7204
09/020,699
Art Unit 2187

REMARKS

This Amendment is submitted in response to the Final Office Action mailed on November 7, 2000. Claims 1, 2, and 4 - 20 are pending. All are allowed, except claims 14 - 16, which are rejected.

FIG. 1

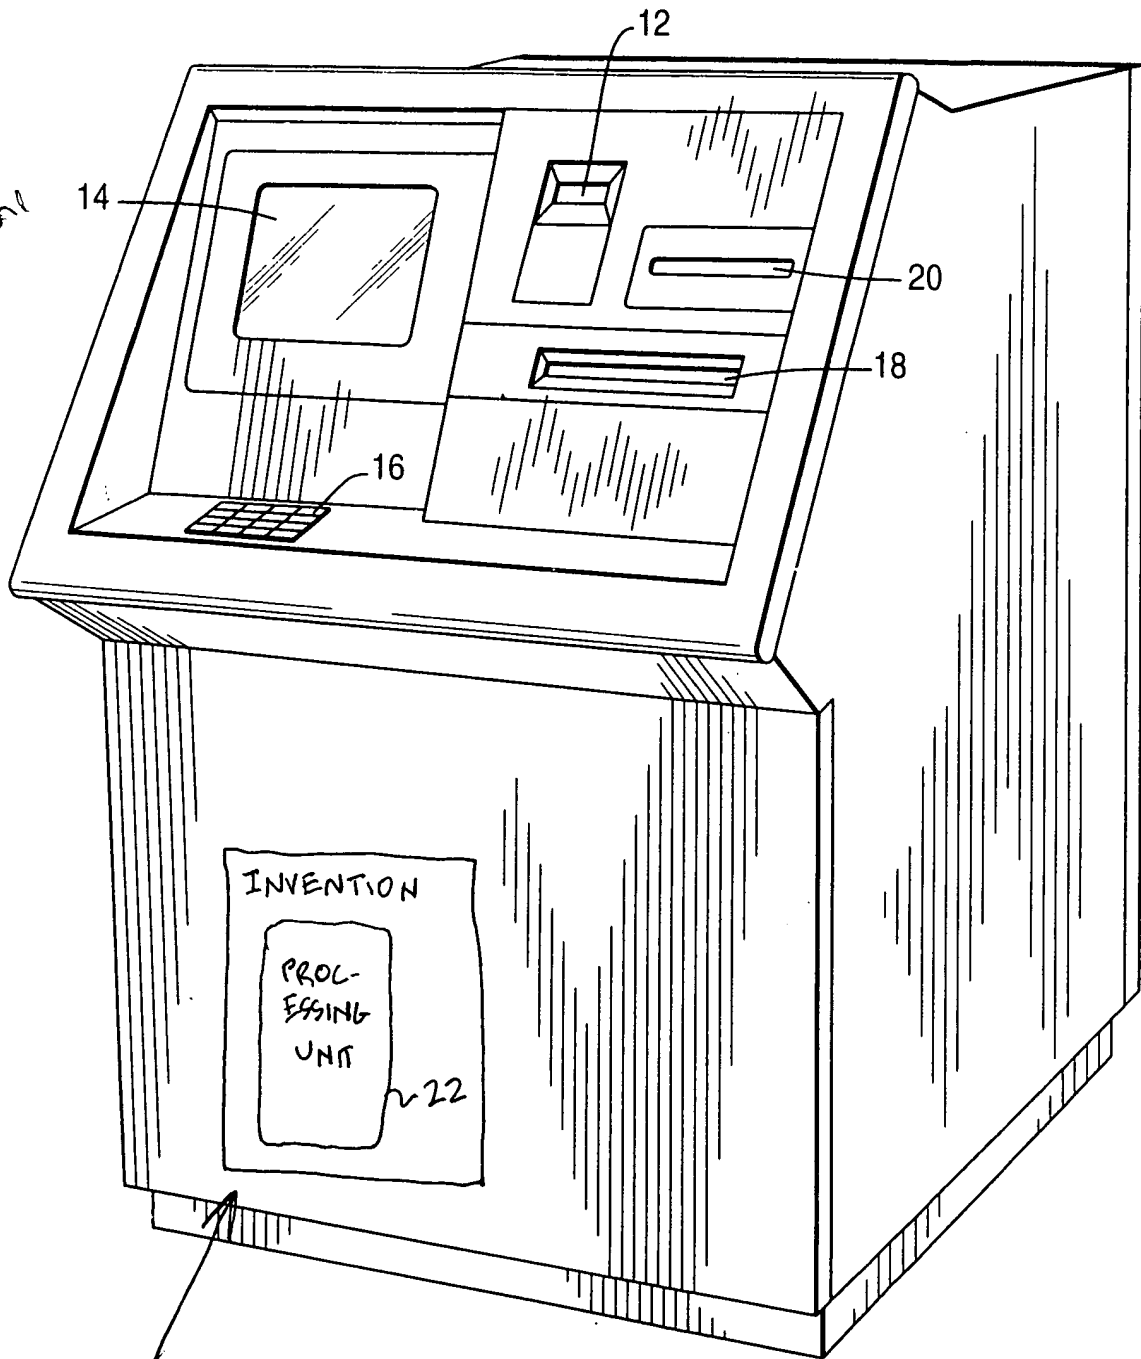
Applicants request that the objection to Figures 1 and 2, on the grounds of lacking the legend "Prior Art," be reconsidered and withdrawn. The reasons were stated in the Brief, and are repeated here.

Applicant offers to resolve this apparent problem by the enclosed PROPOSED DRAWING AMENDMENT, which adds a graphical block to Figure 1, within the ATM 10, which is labeled "invention." Support for that block is found in the Specification, as described in the preceding section.

Applicants request that the objection to Figures 1 and 2 be reconsidered and withdrawn, that the Proposed Drawing Amendment be accepted, or that Figures 1 and 2 be labeled as "prior art," subject to the stipulation discussed above.

Do. Not
enter
RFE
7/29/2011
